5.0 Panther House Massing

Approved Planning Schemes vs S73 Proposal

Refine massing of Panther House top

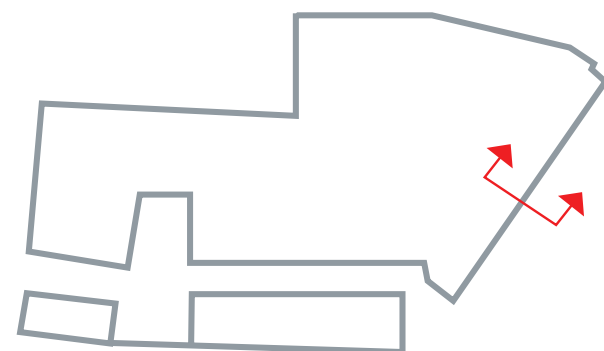
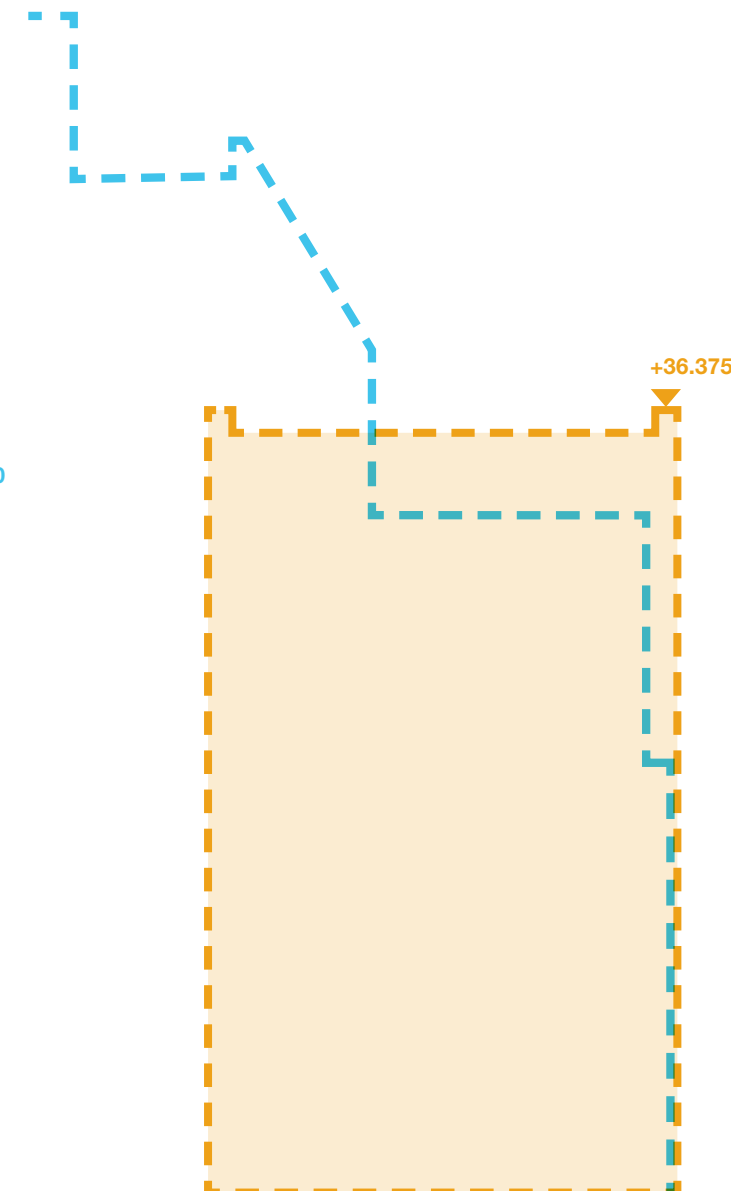
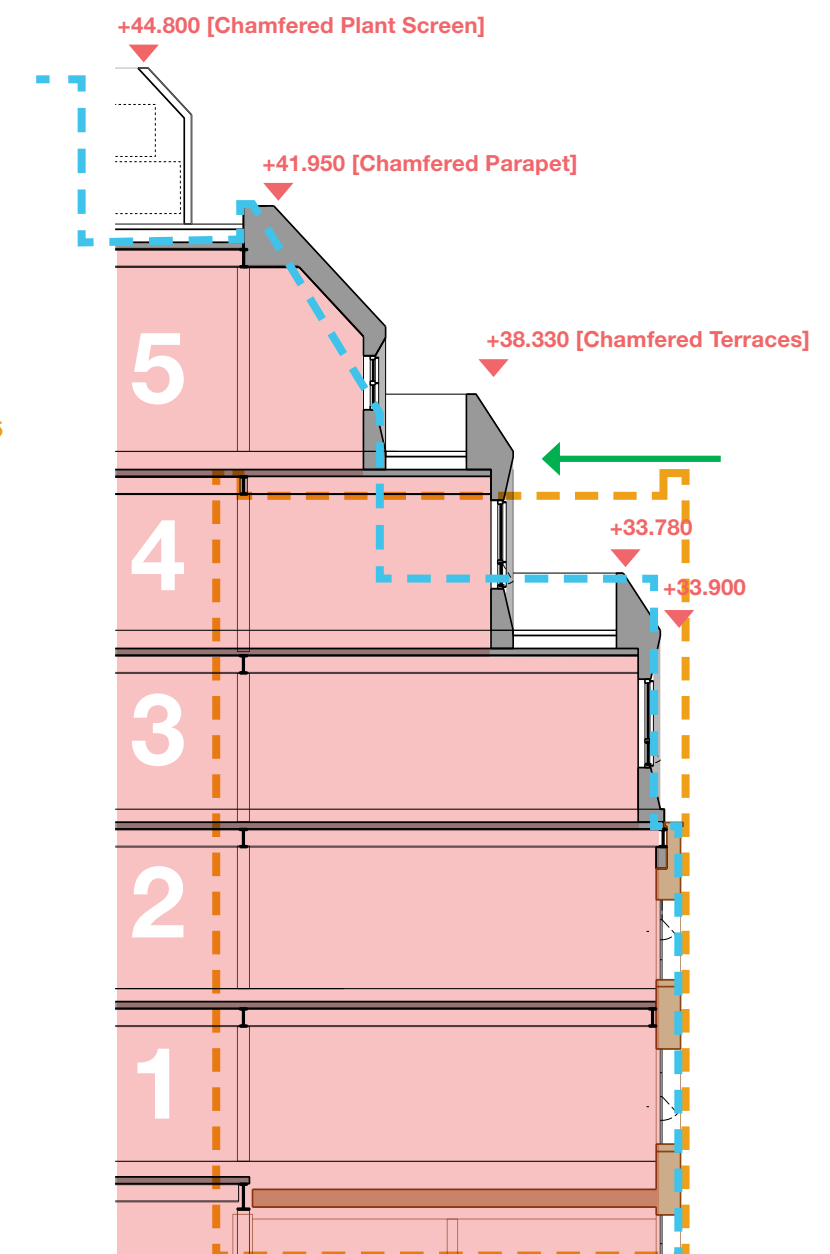
The three partial section diagrams on this page show the three different outlines: The AHMM 2017 approved scheme (blue), The Canno Lasso approved scheme (orange) and the AHMM 2021 s73 proposal.

The new proposed parapet height on Mount Pleasant at level 4 terrace is actually lower than the AHMM 2017 approved scheme. Levels 3, 4 and 5 tier back to reduce the overall massing impact but to also create valuable staff amenity terraces.

All the terrace balustrades have been detailed so that they are integrated as part of the external cladding with a chamfered edge which softens each tier. The proposed chamfer is also introduced at the at roof level for the plant screen to reduce its visual impact.

Panther House Elevation

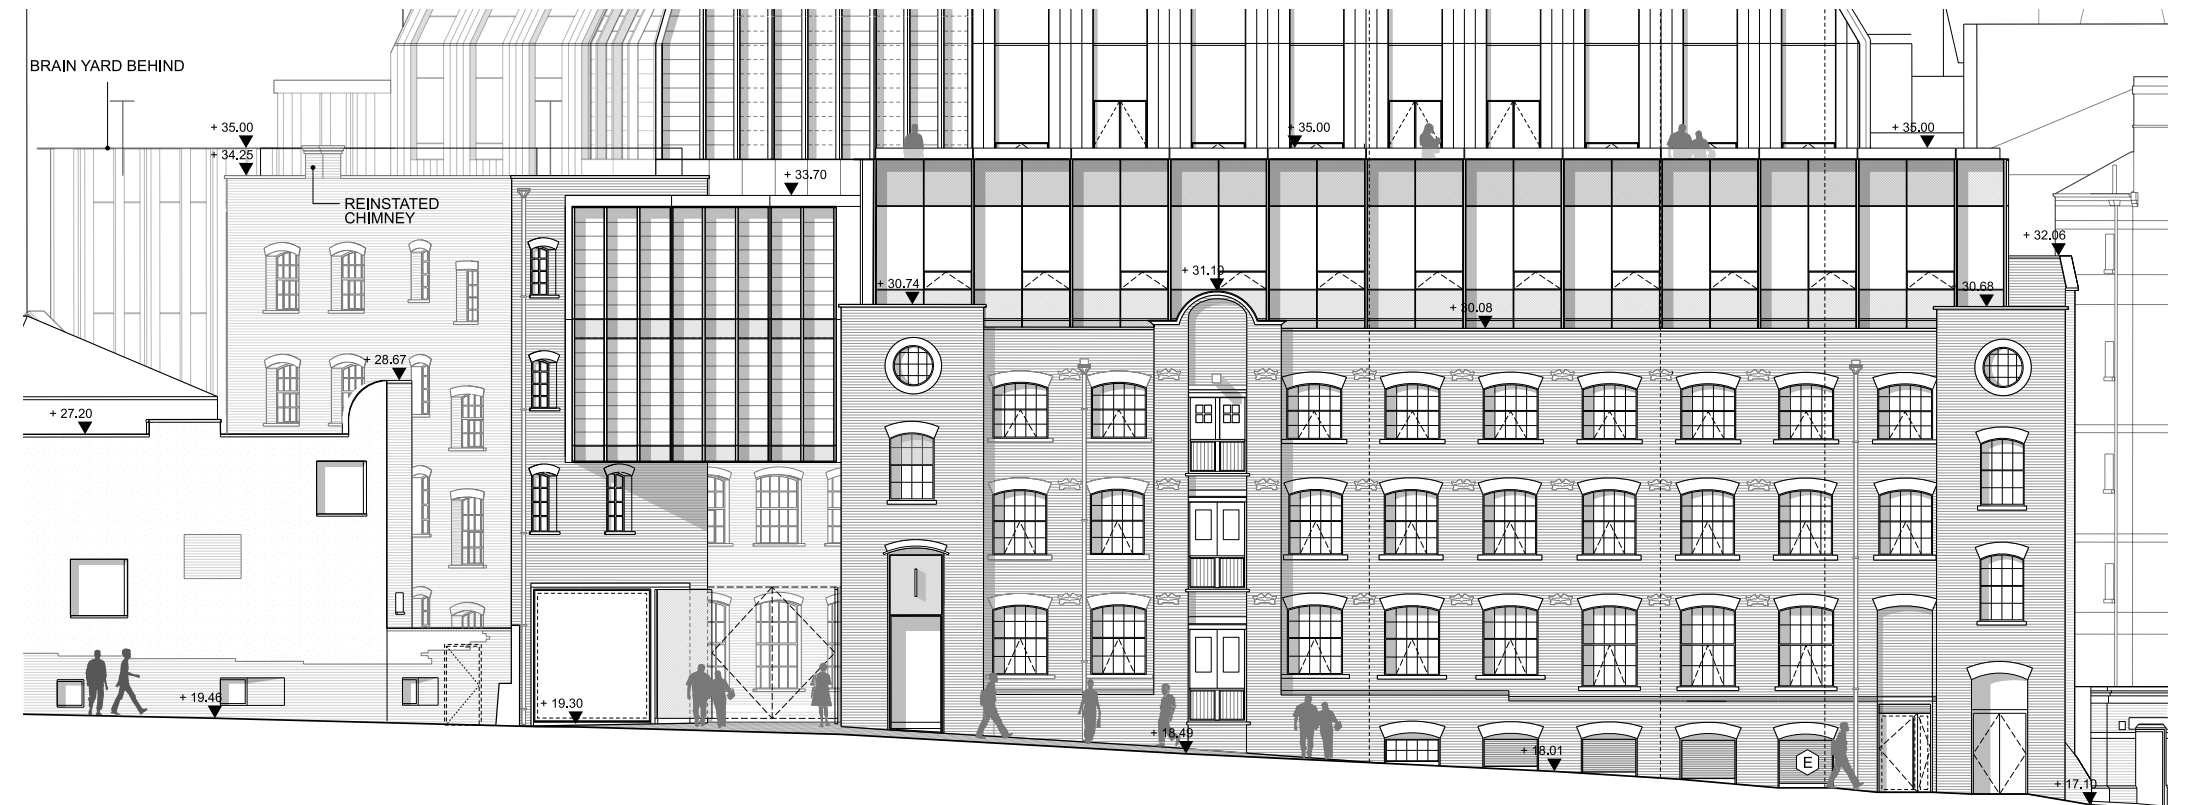
As illustrated in the elevation drawings on this page, the proposed s73 elevation seeks to work better with the existing Panther House building. The new punched windows on the roof extension align with the existing Panther House windows so that an overall consistency is achieved.

The various levels also tier and cascade backwards to make the massing and envelope appear more recessive.

Chamfered edges articulate each floor to further soften the overall impression.

S73 Proposal | Panther House Partial Elevation

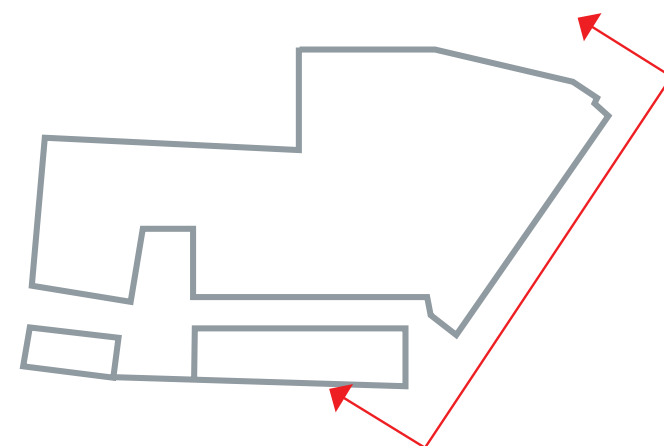
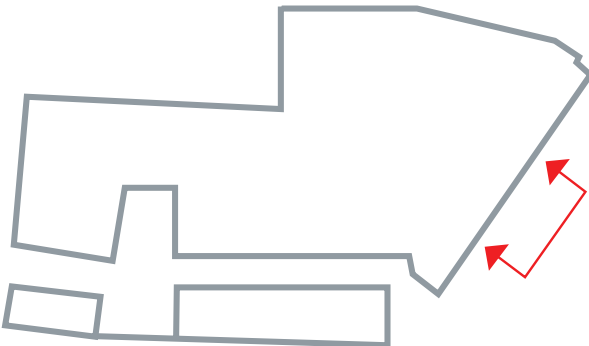
Improvements to the existing Panther House Mount Pleasant elevation are also proposed; the loading bay doors are replaced with new crital style doors with Juliet balcony to match the window replacements. The approved application also showed the end window above the new bike park entrance to be bricked up. Our new proposal seeks to maintain the existing window opening and install a new crital window to match surrounding sets to provide crucial daylight to the bike park entrance lobby.

Panther House View from South

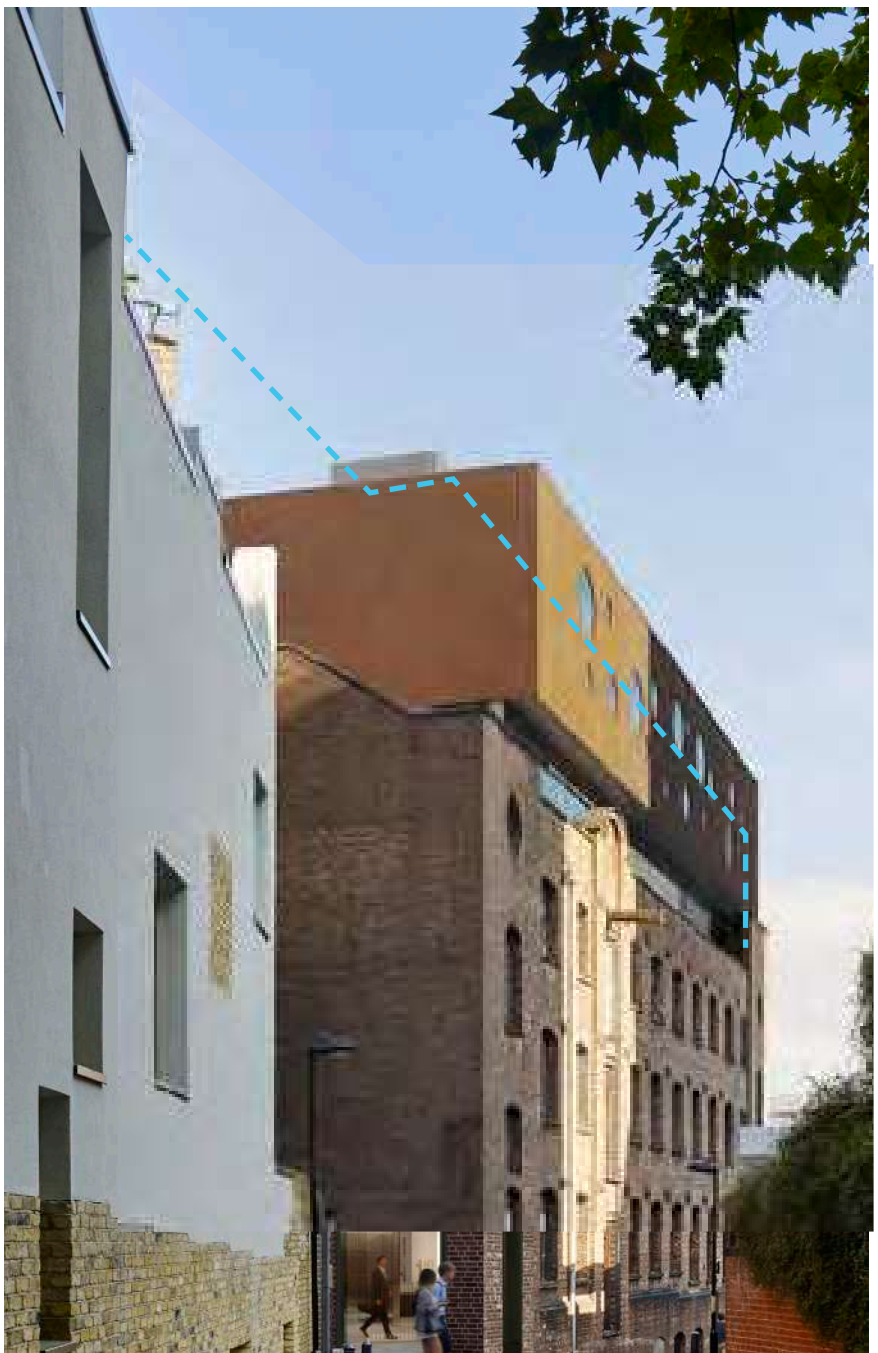
The views here show how the proposed massing and in particular level 4 is visibly beneath the AHMM approved 2017 massing and much lower than the approved Canno Lasso parapet height on the Mount Pleasant elevation

Panther House roof plant is not visible.
